SUNDRY NOTICES AND REPORTS ON WELLS
Do not use this form for proposals to drill or to re-enter an abandoned well. Use form 3160-3 (APD) for such proposals.

8. Well Name and No.
BIG EDDY UNIT D12 2H

BOPCO L.P. requests to change plans as follows:

Big Eddy Unit DI2 #2H
BOPCO L.P.
Conditions of Approval

Diagram Z

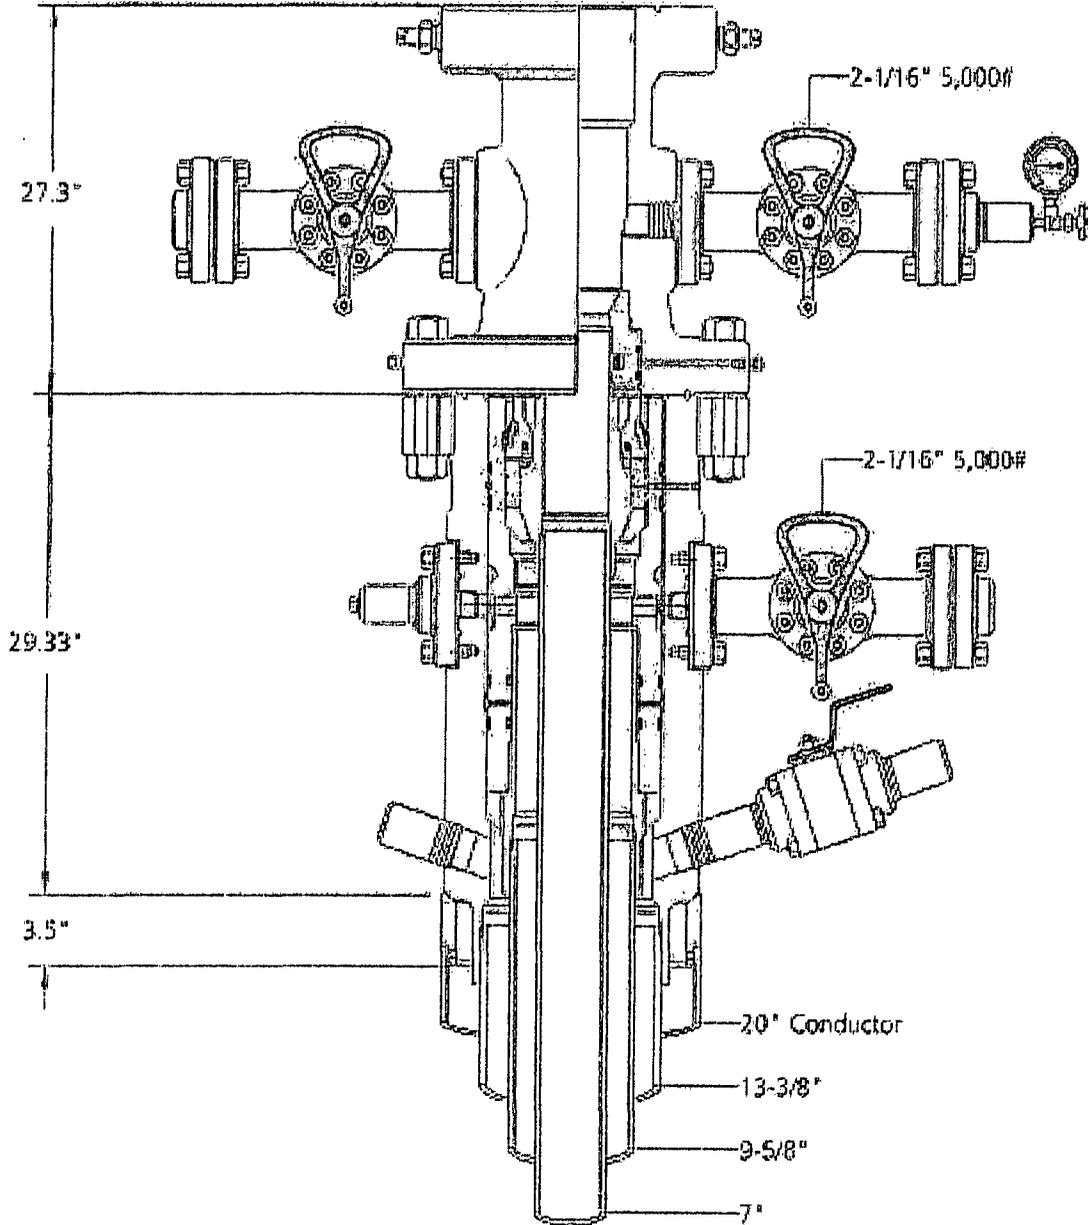
Change plans for BOP testing due to the utilization of a Cameron MBS wellhead for the 7? intermediate casing. We request to nipple up and test BOPE on the 9-5/8? intermediate casing to 250 psi low and 3,000 psi high, which will cover the testing requirements for the remainder of the well. The 7? casing string will be tested as per Onshore Order #2 prior to drilling out the shoe. The Cameron wellhead diagram is attached for reference.

5. **Operator has proposed a multi-bowl wellhead assembly. This assembly will only be tested when installed on the 9-5/8 inch 2nd intermediate casing. Minimum working pressure of the blowout preventer (BOP) and related equipment (BOPE) required for drilling below the surface casing shoe shall be 3000 (3M) psi.**

- a. **Wellhead shall be installed by manufacturer's representatives, submit documentation with subsequent sundry.**
 - b. **If the welding is performed by a third party, the manufacturer's representative shall monitor the temperature to verify that it does not exceed the maximum temperature of the seal.**

- c. **Manufacturer representative shall install the test plug for the initial BOP test.**
 - d. **Operator shall perform the 7" casing integrity tests to 70% of the casing burst. This will test the multi-bowl seals.**

- e. **If the cement does not circulate and one inch operations would have been possible with a standard wellhead, the well head shall be cut off, cementing operations performed and another wellhead installed.**
